66309D-07

S E R V I C E N O T E

66309D - MOBILE COMMUNICATION DC SOURCE, DUAL-OUTPUT 15V/3A,12V/1.5A. GPIB

Power-On Self test Errors, Auto reboot, Blank display. No output Communication errors. No communication when using the GPIB Interface.

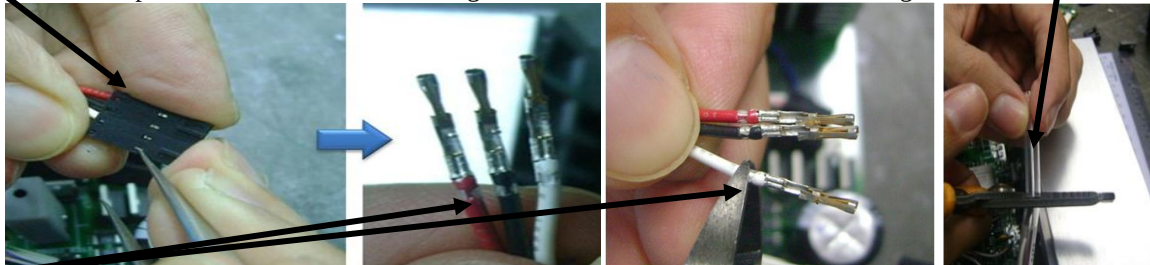
The cable P/N 5080-2452 coming from the control board should be disconnected for the mail connector (circuit reference) "J206" which is soldered on the interface board.

Remove the connector P/N 1252-3695 (circuit reference) "J206" on the "A2" interface assembly. When removing "J206" care should be taken not to damage the "A2" printed circuit board material or the circuit board traces. "J206" has 4 holes remove the solder from these holes as shown. Do not apply too much heat or pressure this may cause damage to the PCA

Remove the pins from the connector housing as shown. Cut 3cm off the clear tubing of the cable

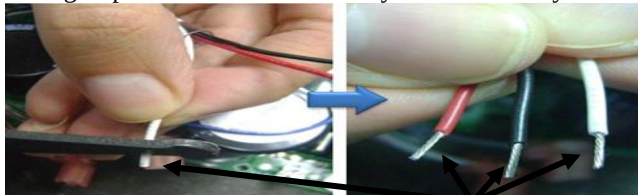
Cut the crimped terminals at the crimp around the wires colored insulation. This is done so the cable length can be as long as possible a short cable may cause assembly issues.

Each wire in the cable should be striped to 5mm. **CAUTION:** Inspect each wire for defects such as cut strands and damaged insulation,

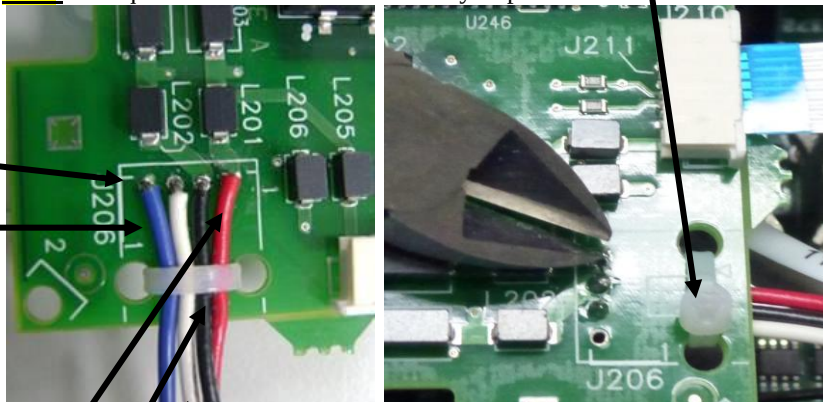
Insert the cable into the open holes located on the “A2” GPIB interface assembly.

Depending on the model there may be three or four wires.

Inspect the wires on the top and bottom of the “A2” GPIB interface assembly.

The **Red** wire is soldered in the main control board (reference E320) and should be soldered into pin #1 or the square pad of “J206” on the “A2” interface assembly.

The **Black** wire is soldered in the main control board (reference E324) wire should be soldered into pin #2 of “J206” on the “A2” interface assembly. .

The White wire is soldered in the main control board (reference E321) should be soldered into pin #3 of “J206” on the “A2” interface assembly.
